ADDENDUM NO. 1 TO 11-3-2-4

FOR: Tatemville Community Center Expansion

Tatemville Community Center Expansion Addendum #1

SD1

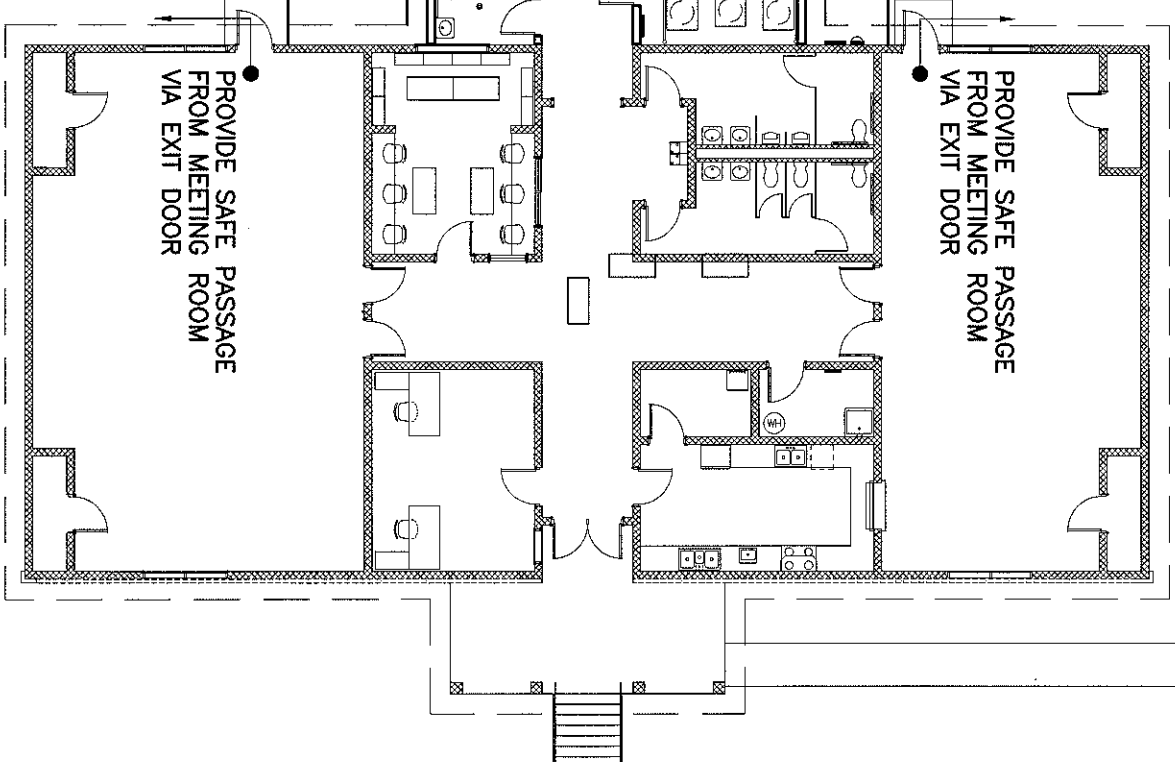
**SEE ATTACHED SEVEN (7) SHEETS WHICH INCLUDE CLARIFICATIONS, CHANGES, AND SUPPLEMENTAL DOCUMENTS: SD1 Added hose bibb.
SD2 Construction fence
133419 Metal Building Systems**

- 1.6 **Sheet P1.0:** Refer to SD1 for the addition of a Hose Bibb.
